# 118 MERCER

SDCI #3036517-LU (3036455-EG)

DESIGN REVIEW BOARD RECOMMENDATIONS

# EDG PRIORITIES AND BOARD RECOMMENDATIONS - 1A PREFERRED MASSING

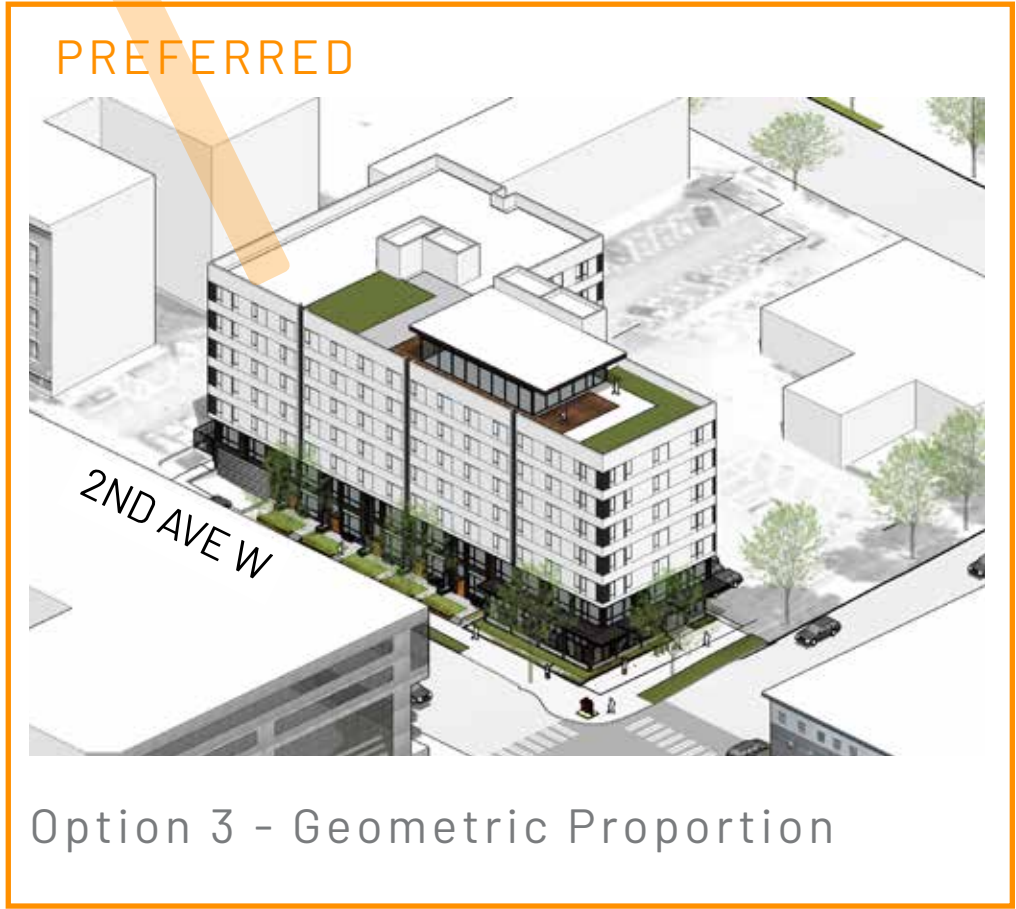
The board preferred Option 3 over the other two massing options due to its taller two-story base height compared to the other options and its incorporation of regular façade reveals on the street-facing upper-facades. (CS2.A, DC2.1.A)

The design continues developing option 3. Option 3 is defined by its two-story base, standalone penthouse (sky lounge), and gaskets. Compared to the other massing studies, the preferred massing option 3 provides an appropriate scale and proportion.

# EDG PRIORITIES AND BOARD RECOMMENDATIONS - 2A PREFERRED PROGRAMMATIC LAYOUT

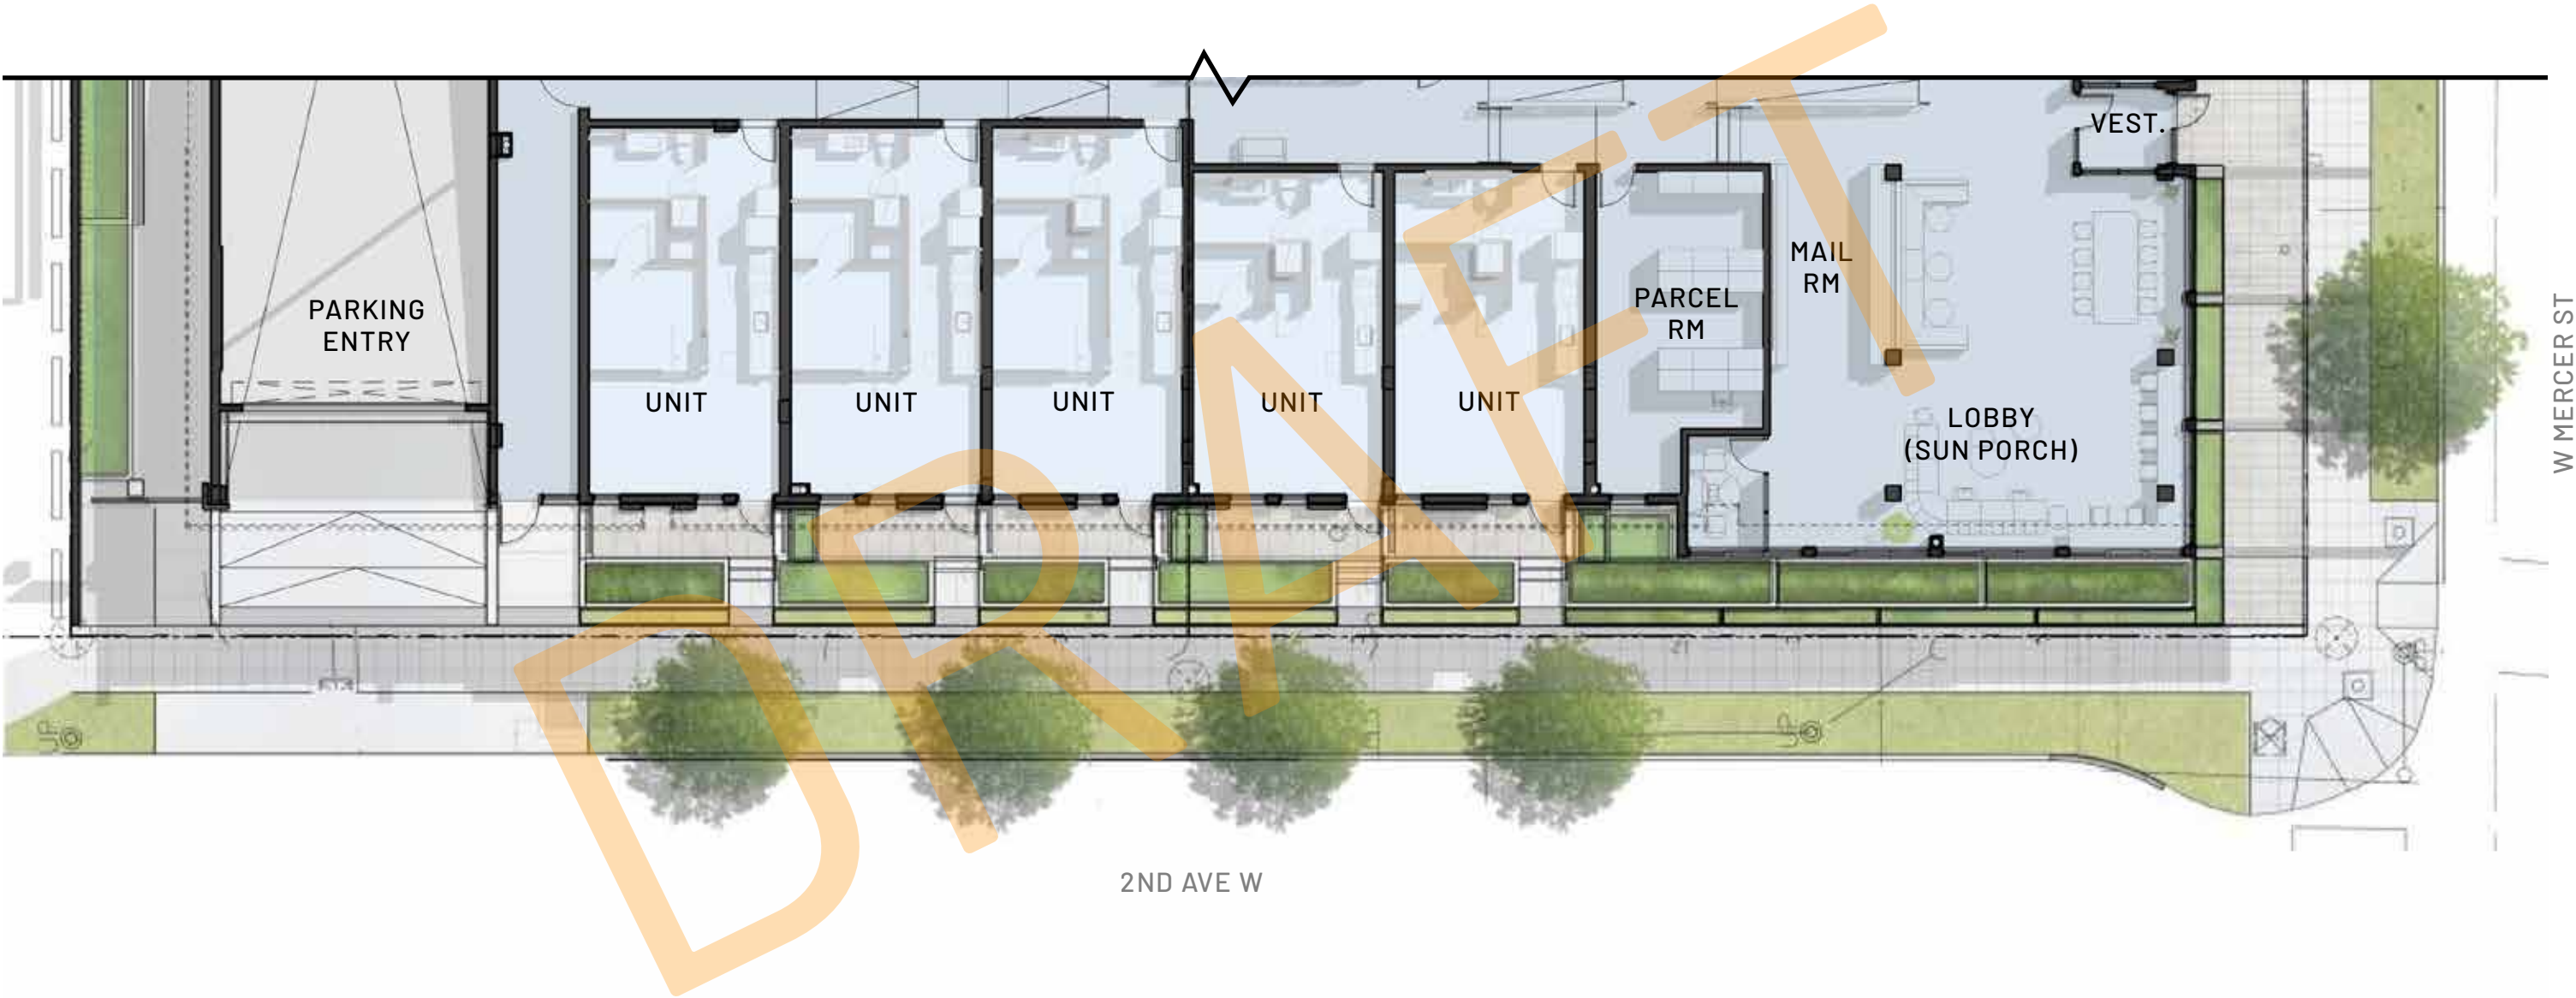
The board supported the programmatic layout of the ground level and intent for residential frontages along 2nd Avenue W. with stoop entrances. (PL3.A.1.d, PL3.1, PL2.3.A).

The programmatic layout of the ground floor and residential frontages along 2nd Ave has been retained. The design further develops the strength of the stoop elements.

EDG PRIORITIES AND BOARD RECOMMENDATIONS - 3A & 3B OUTDOOR STREET FRONTAGE

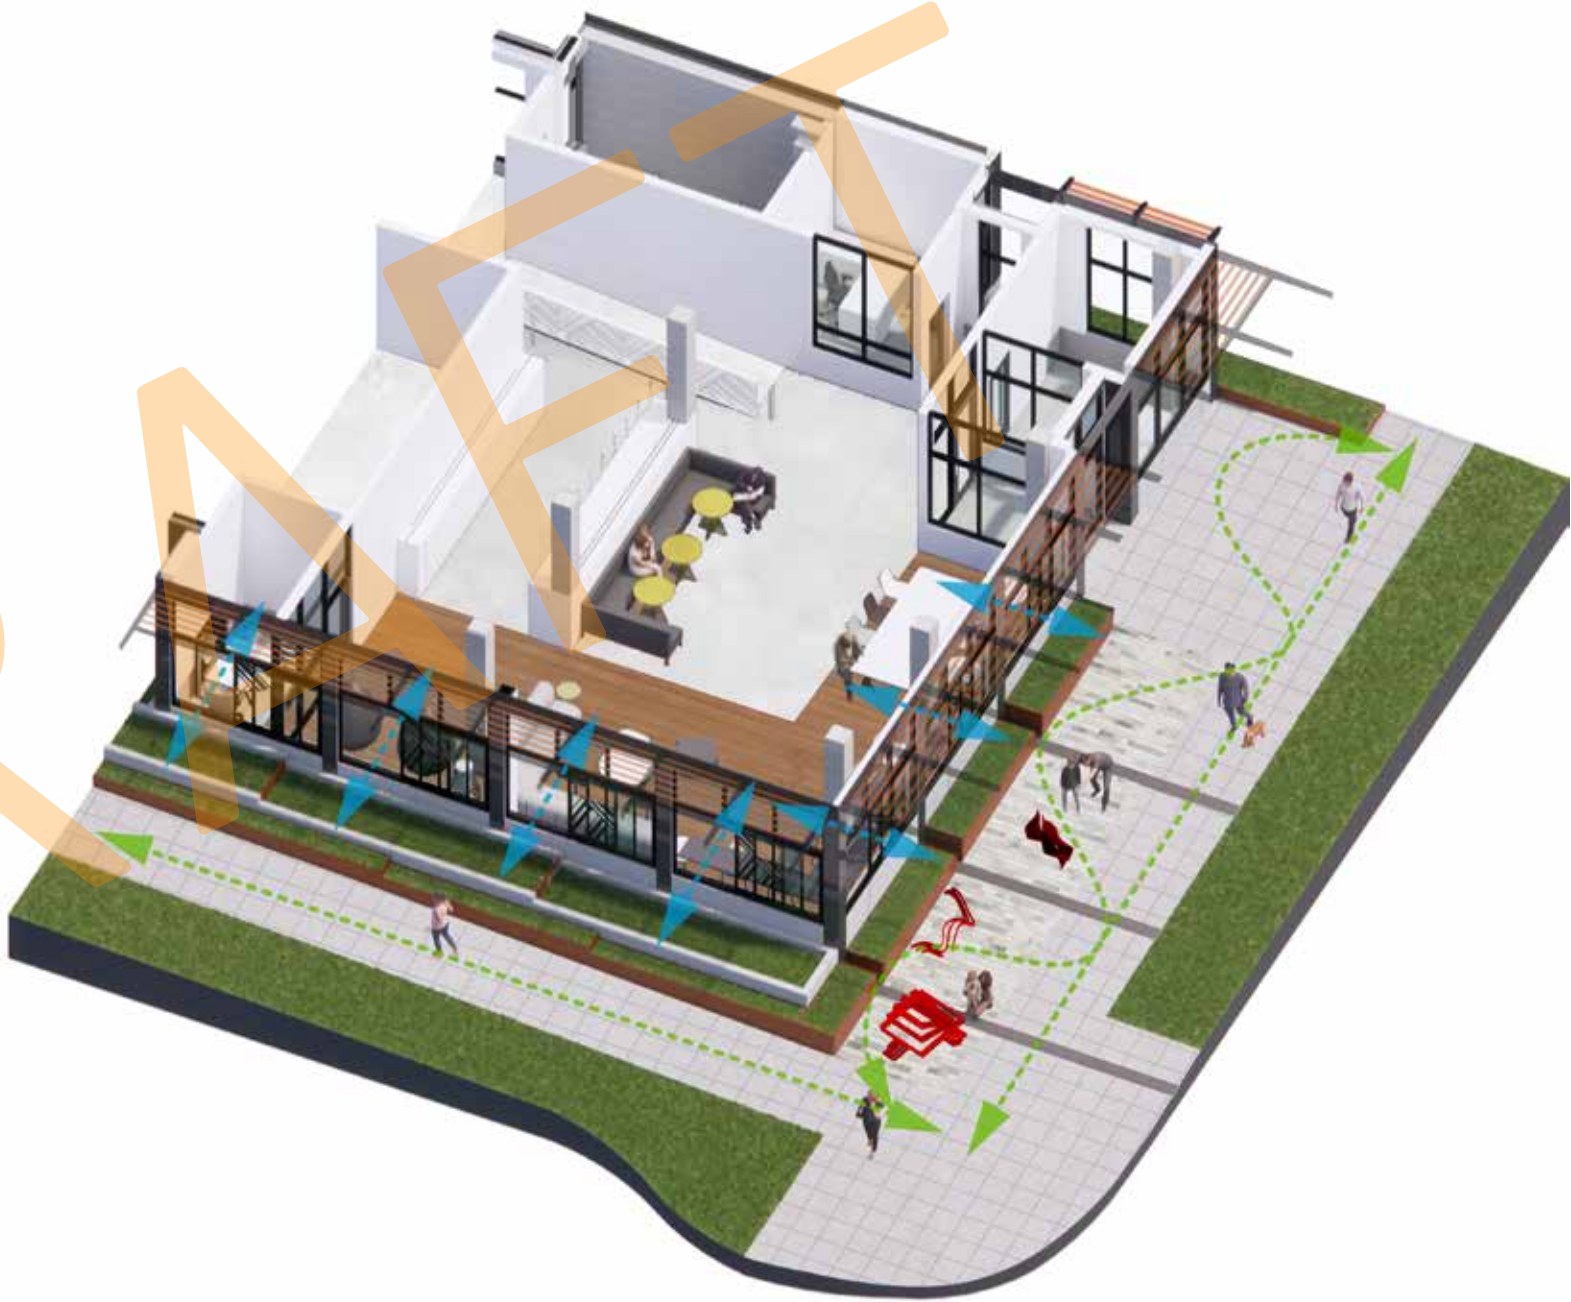
The Board requested additional study of the design and programming of the plaza along W. Mercer Street to show that it will effectively function as a nuanced space that allows for congregation and effectively connects the sun porch to the sidewalk and, instead of serving only as an extension of the sidewalk. The additional study should include examination of pedestrian movements and design details like planter dimensions and plant sizes (Uptown CS2.3.C. Corner Sites-Special features, Uptown PL1.1.A. Connections, Uptown PL1.3.C. Pedestrian Uses, Uptown PL4.2. Planning Ahead for Bicyclists)

Related to comment 2b, the Board expressed concern that a significant amount of the street frontage was designed as a landscape buffer separating the building from sidewalk and plaza areas. The Board requested additional study showing how the public would occupy or use this landscaped area and adjacent public space and how this landscape area will aid in connecting indoor and outdoor spaces surrounding the sun porch (Uptown CS2.3.C. Special features, Uptown PL1.1.A. Connections, Uptown PL1.3.C. Pedestrian Uses)

The design team has continued to study and refine the relationship between the sun porch and the public space with the goal of encouraging connection. A cohesive strategy of specialized paving, landscape features, building elements and artwork installations have been developed to connect the interior and exterior spaces.

Rather than treat the plaza as an extension of the sidewalk, the sidewalk is reclaimed as part of the plaza and sun porch element. Like a wide point in a river, the current of the pedestrian experience within the space is slowed down by providing a meandering path filled with points of visual interest (paving, landscape, art) as well as active connection to the sun porch interiors (operable windows).

# EDG PRIORITIES AND BOARD RECOMMENDATIONS – 1B ARCHITECTURAL PROMINENCE

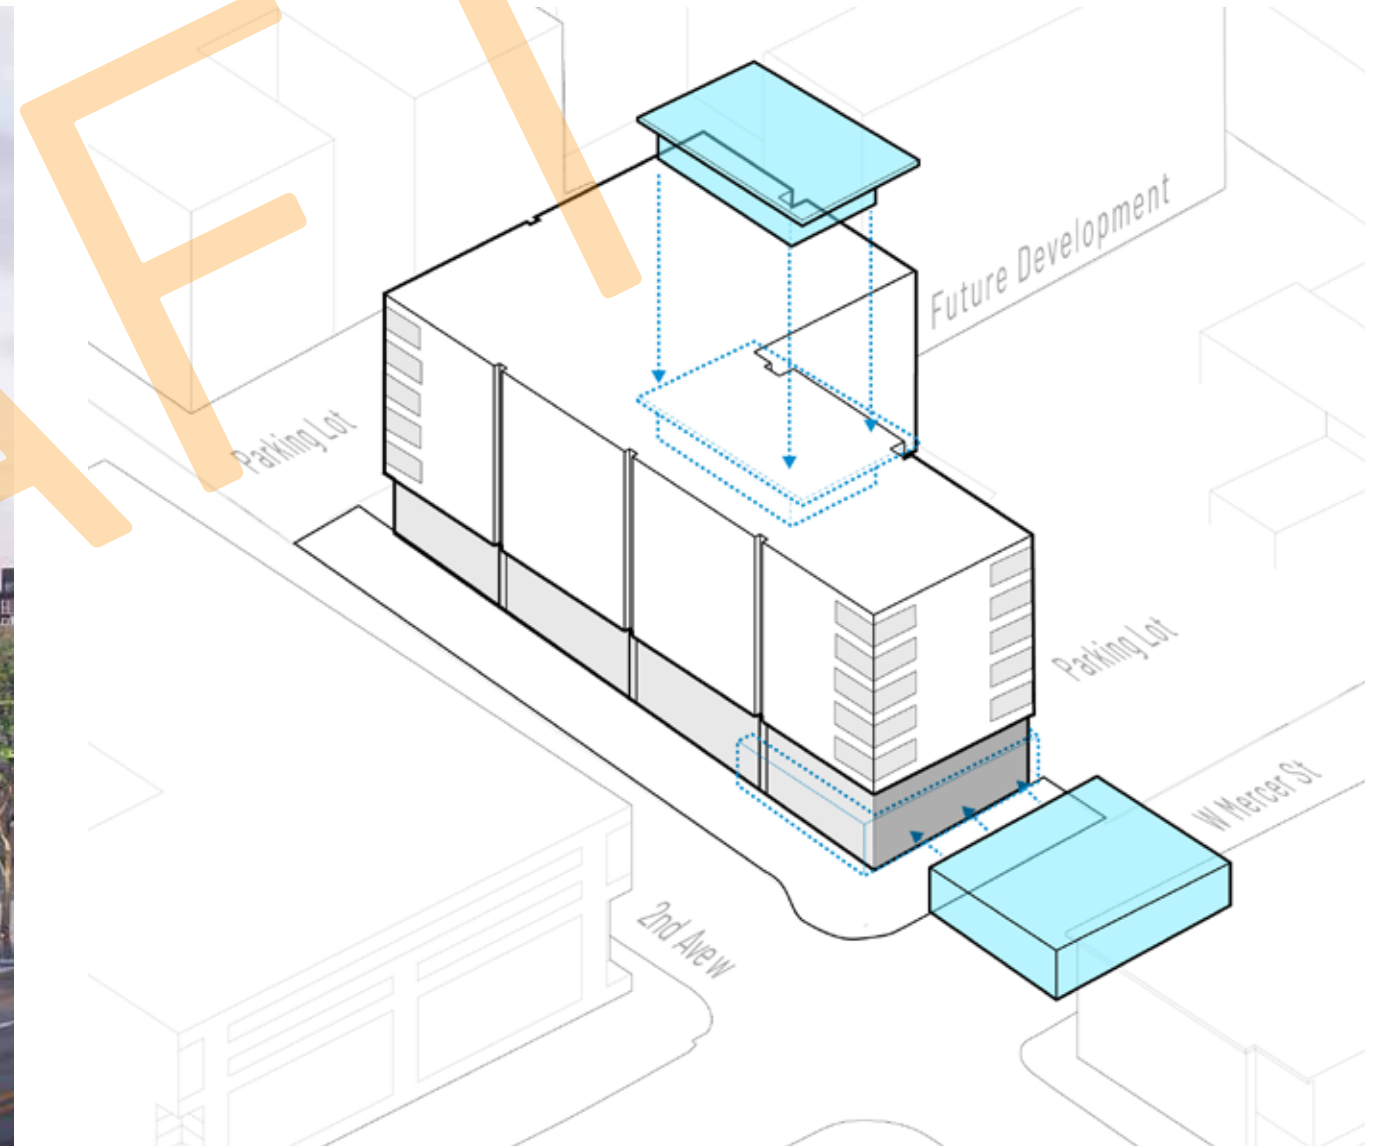
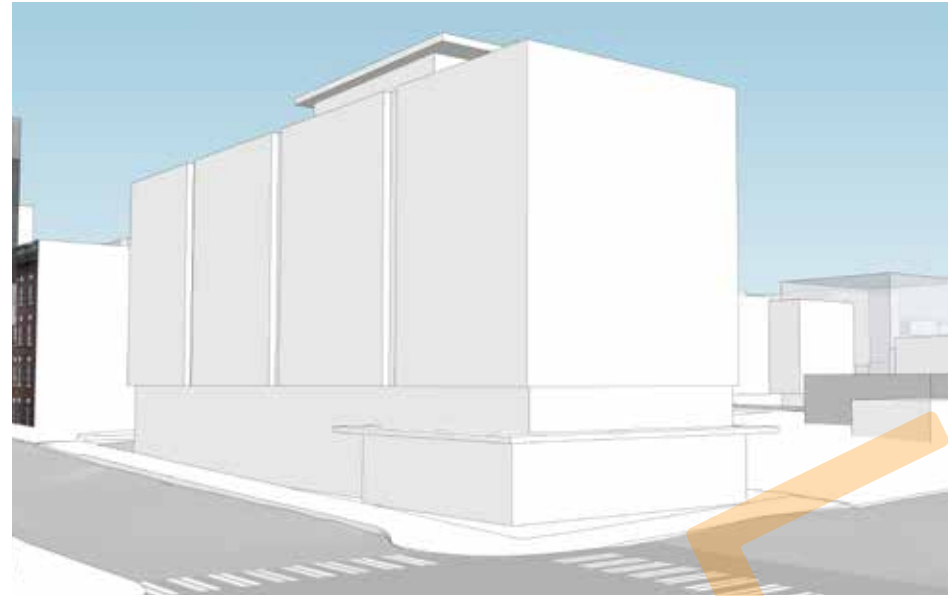
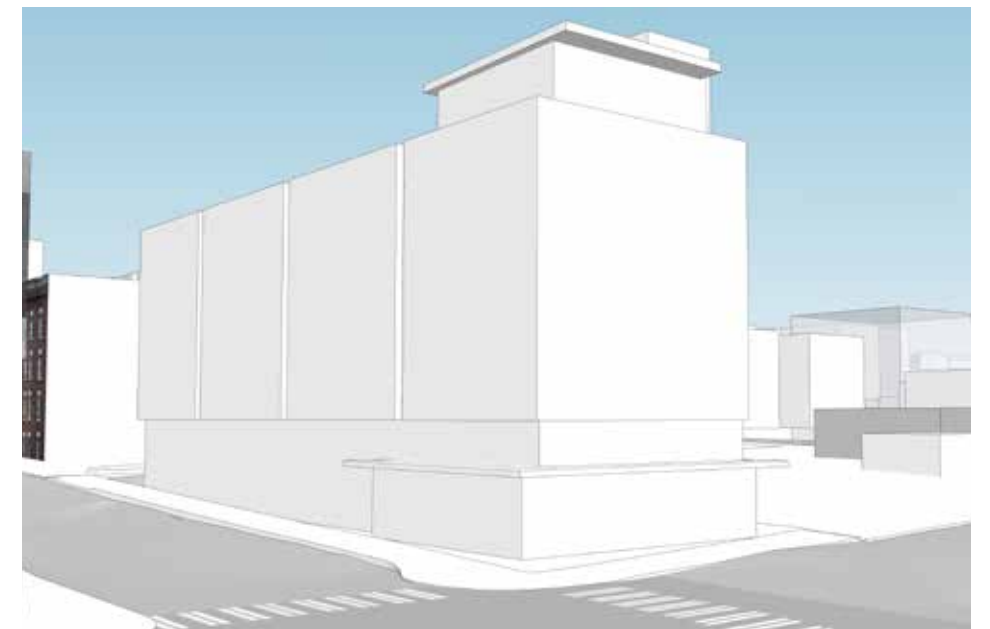
The Board identified the need to strengthen the massing expression of the southern portion of the Option 3 building design near the street intersection. The taller massing of Option 2 was cited by the Board as a possible solution that would add architectural prominence at the street corner and better relate to contextual building heights. The Board specified that adding prominence through height should express the southern massing without being imposing to surrounding development (CS2.A, CS2.D.3, DC2.C.3)

Per recommendation, the design team completed a handful of massing studies to explore techniques which add prominence to the southern massing.

As suspected by the Board, adding mass to the southern volume created an imposing condition at the corner upon the intersection and pedestrian environment (Study 5). Adding a top element at the corner unduly weakened the design parti (Study 6). Different methods of articulating the corner through erosion were explored within the more appropriate 7-story corner volume (Study 2/3/4), however none of these studies yielded a more striking upper volume than that which had been previously provided.

As shown on this page, the design is best served by the increased prominence of the sun porch element and its connection to the ground floor plaza which reinforces the scale of the pedestrian realm. The contrast of the highly articulated “jewel-box” and the clean rigor of a consistent 5-story upper volumes appropriately celebrates the corner, while upper art panels both soften and highlight the facade transitions.

# EDG PRIORITIES AND BOARD RECOMMENDATIONS – 1C SECONDARY ARCHITECTURAL FEATURES

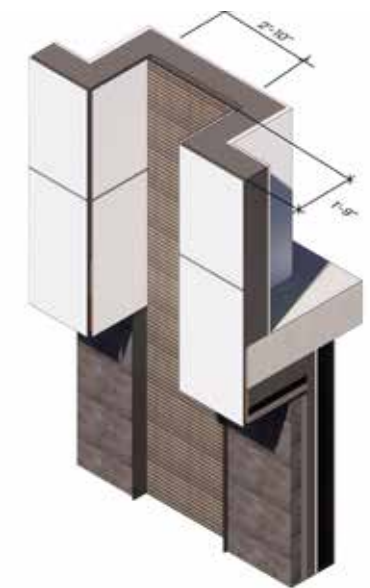
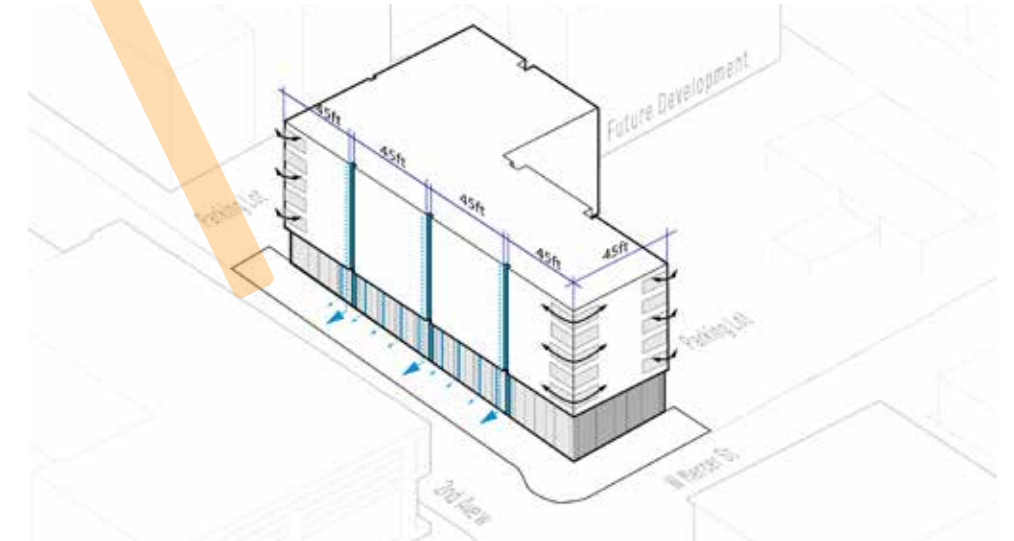
The board emphasized the need to break-up the relatively long upper-façade along 2nd Avenue W. of Option 3 using both larger massing moves, such as increased width and depth of façade reveals, and secondary architectural features. The board specifically identified the vertical gaskets along the east building façade as sufficiently-sized massing elements that could be implemented on the west façade. (DC2.A.1, DC2.A.2, DC2.C)

Gasket depth along 2nd Ave W have been increased by 20% (from 1'-8" to 2'-0") and widened by 33% (from 2'-0" to 2'-8") with an additional gasket added along the north facade.

Per recommendation, the design team completed a handful of massing studies to explore techniques that incorporated larger massing moves into the upper facade, including using similar size gaskets to those on the east facade. We were therefore able to observe that wider gaskets (Study 3) in fact weaken the strength of the upper form, while deeper gaskets (Study 5) weaken the contrast between the two-story base and five-story upper facade.

Additional studies of facade proportion (Study 4) and accent materials (Study 2) were undertaken in order to test other techniques, however within the context of the design concept these moves became arbitrary, detracting from the overall rigor of the parti.

## EDG PRIORITIES AND BOARD RECOMMENDATIONS – 1E ART INTEGRATION

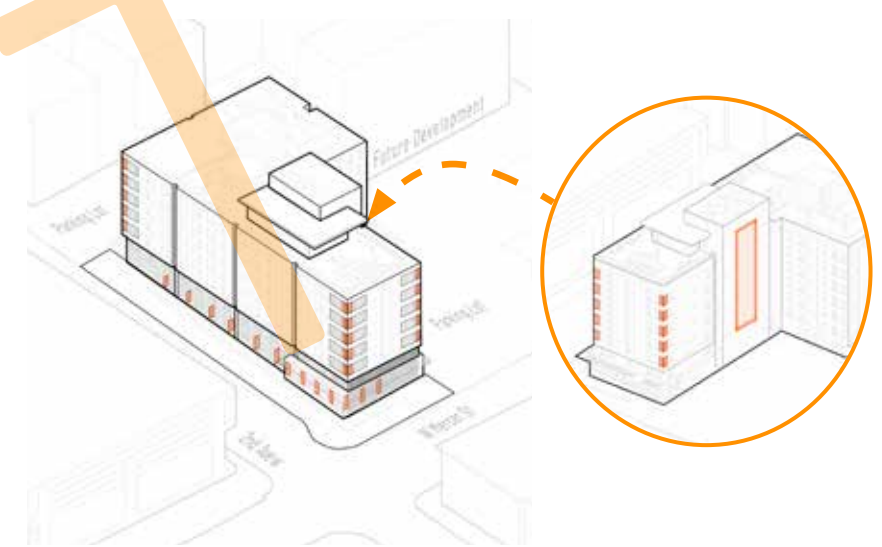
The board identified (Artwork & Murals) as priorities, but didn’t offer specific guidance related to these items. (CS3.1.b, DC2.2.a)

As noted in the previous EDG responses and throughout this DRB package, artwork remains an integral part of the design concept. Outreach to muralists and sculptors underway, with the goal of presenting final concepts to the Uptown Alliance for neighborhood approval in early summer.

The design team does not intend to limit the artists' thematic approach, but has instead requested a holistic concept proposal that utilizes strong geometries that lends to pattern recognition between three dimensions (sculpture) and two dimensional (art panels/mural). Suggested inspirations include the greater Pacific Northwest, Uptown's history and the forms of the nearby Pacific Science Center.
